Charlotte-Mecklenburg Planning, Design, & Development

SUBJECT: Administrative Approval for Petition No. 2007-052 The Ghazi Company

CITY
CROSSING

Rezoning Petition
2007-52

RZ-2

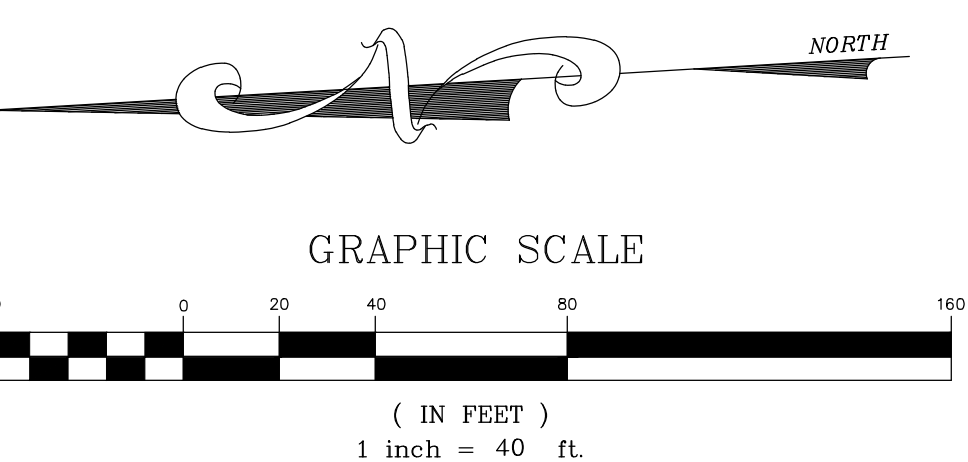
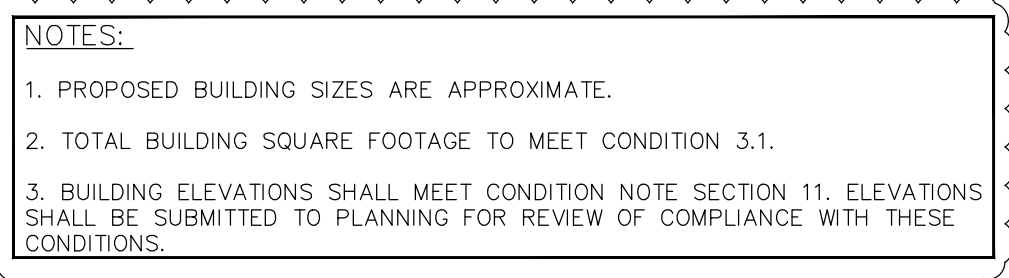
- To allow site modification and layout changes.
- Note that elevations will need to be reviewed by the Planning Department.
